Planning condition 14 - Electric car charging

Date: 28.01.25	Project: Bankfield Drive, Holmebridge
Scale @ A3: NTS	Drawing Number: 2405-03-006 Electric car charging plan
Drawn By: CD	Revision: A

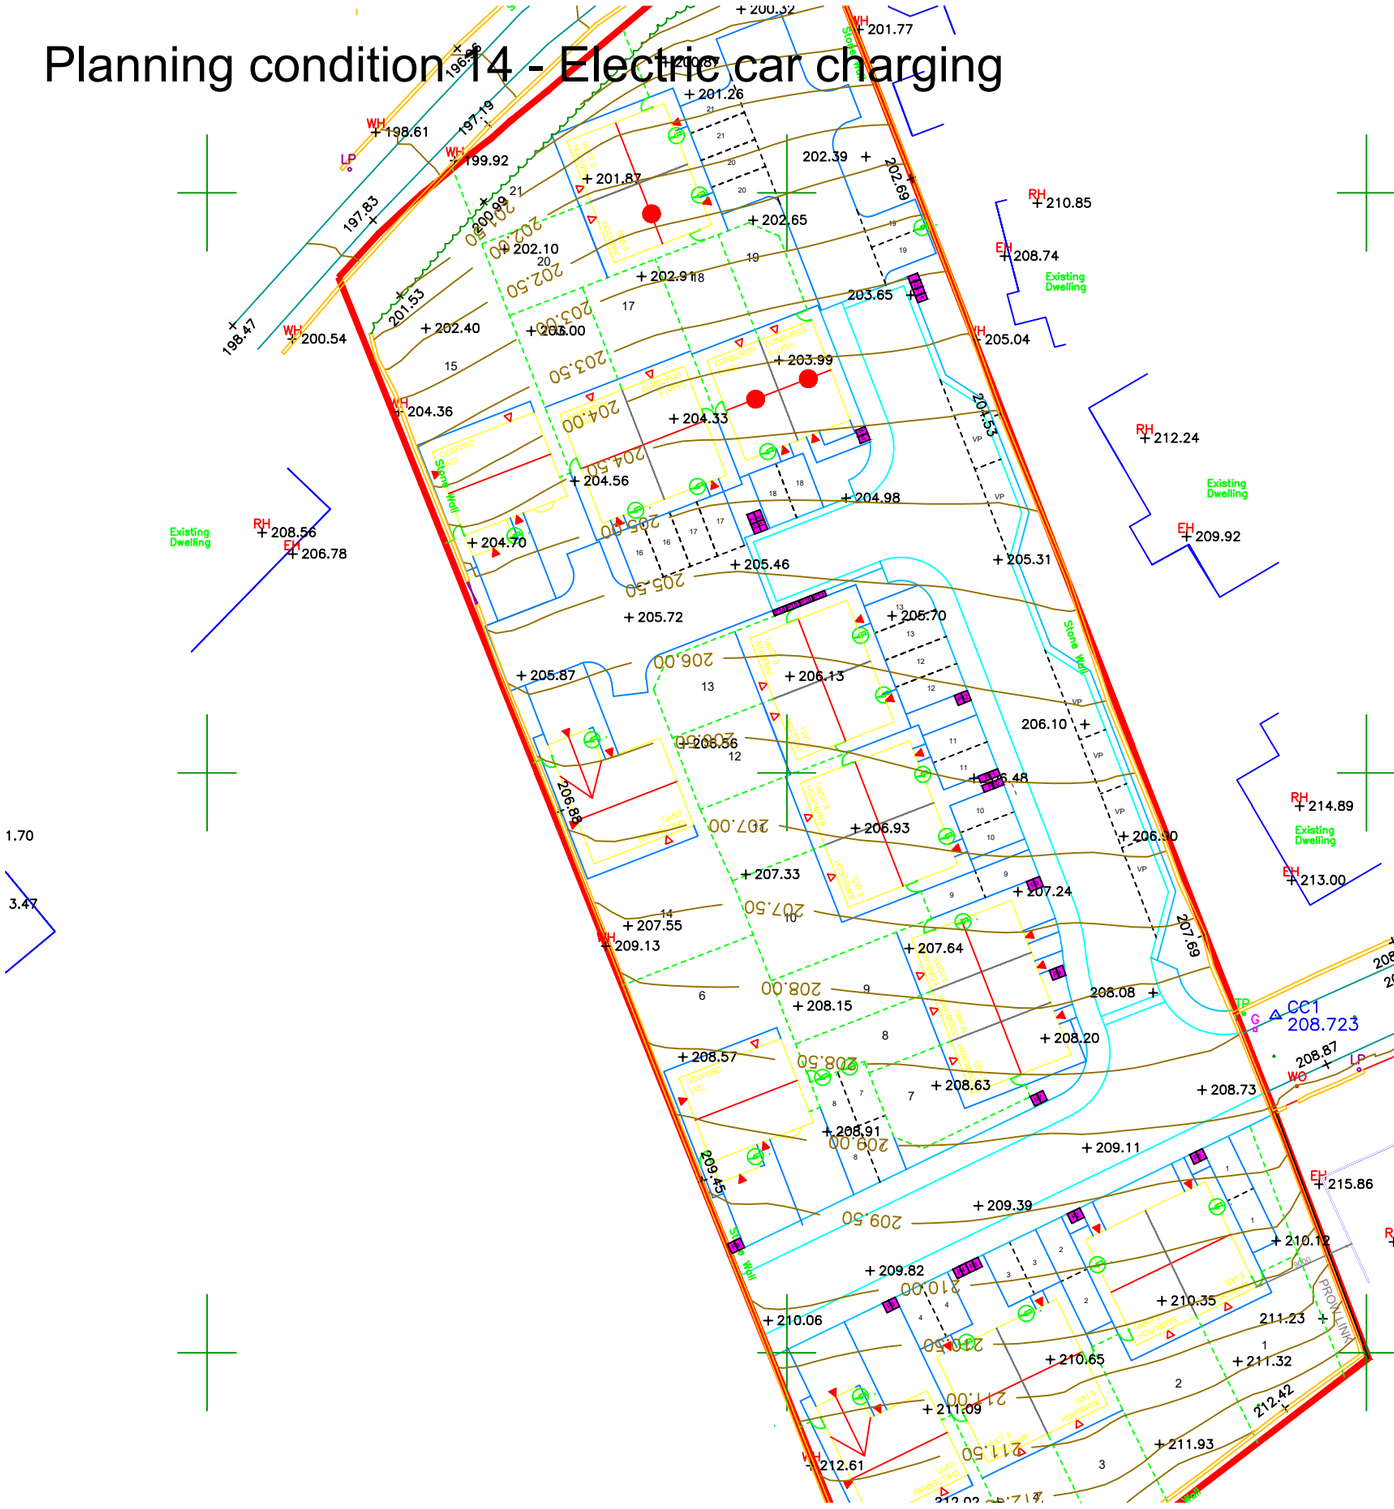
Revision notes:		
Rev:	Date:	Notes:
A	02.04.25	Note regarding cabling and circuitry added - CD

NOTE: The cable and circuitry ratings for the EVCP shall be of adequate size to ensure a minimum continuous current demand of 16Amps and a maximum demand of 32Amps.
